# UNITED STATES PATENT AND TRADEMARK OFFICE

APPLICATION NO.	FILING DATE	FIRST NAMED INVENTOR	ATTORNEY DOCKET NO.	CONFIRMATION NO.
10/659,395	09/11/2003	Youichi Konno	031141	3764

**Office Action Summary**

## DETAILED ACTION

**Roth et al Fig. 32A**

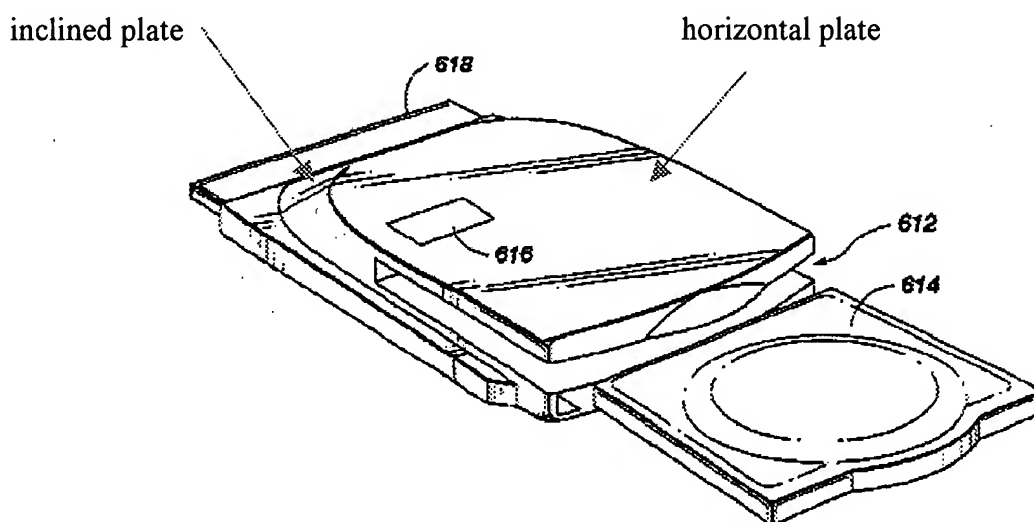
As recited in claim 1, Roth et al show a disk drive (see Figs. 32A-B) comprising: a main unit (upper left in 32A) which comprises a disk-driving unit (inherent) for rotating a disk, a data-

reproducing unit 616 for reproducing data from the disk, and a drive unit (inherent) for moving the data-reproducing unit relative to the disk; and an outer case which has a horizontal plate opposing the main unit and an inclined plate (see Fig. 32A) extending from a rear edge of the horizontal plate, gently inclining and covering the rear part of the main unit.

Roth et al show the claimed connectors 618, wherein the inclined plate is in the vicinity of the connectors (see Fig. 32A).

As recited in claim 4, it appears that the inclined plate of Fig. 32A is flat in at least one region, such that the claim is anticipated.
